**SIGAR 19-55 Inspection Report**

**Afghanistan's Ghulam Khan Road Project:  
Construction of the Road and Bridge Generally  
Met Contract Requirements, but Deficiencies  
Have Created Safety Hazards for Users**

**AUGUST  
2019**

**Photo 6 - 30-Inch High Bridge Railing**

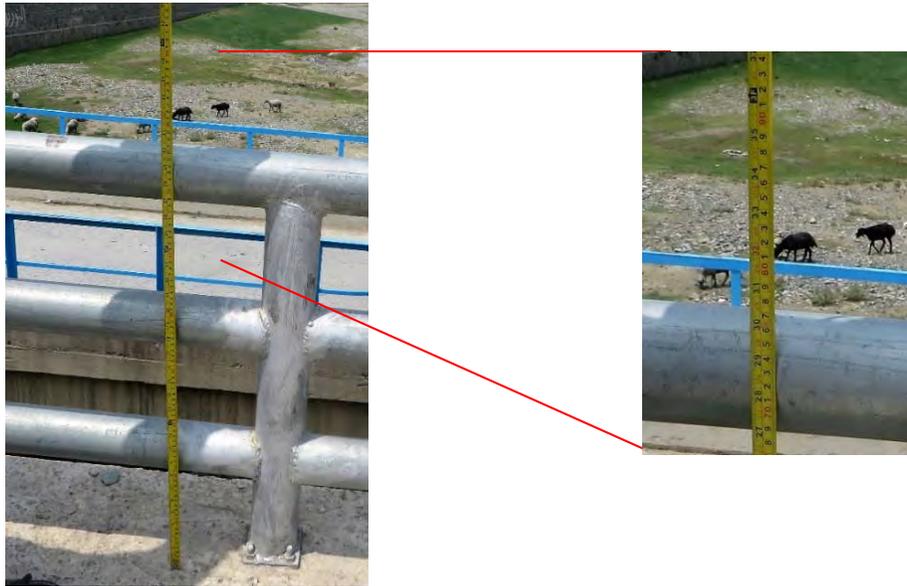
During our July 2018 site visits, we found that BDCI constructed the bridge's pedestrian and cyclist railings, which are bolted on the sidewalk's concrete surface, about 30 inches tall (see photo 6). However, the contract required BDCI to follow the American Association of State Highway and Transportation Officials' standards for bridge design. The standards require pedestrian railings along bridges to be at least 42 inches tall and bicycle railings to be at least 54 inches tall. Although BDCI built the sidewalks on each side of the bridge to accommodate pedestrians and cyclists as required, the low railings create a safety hazard by increasing the risks that they might fall from the bridge.
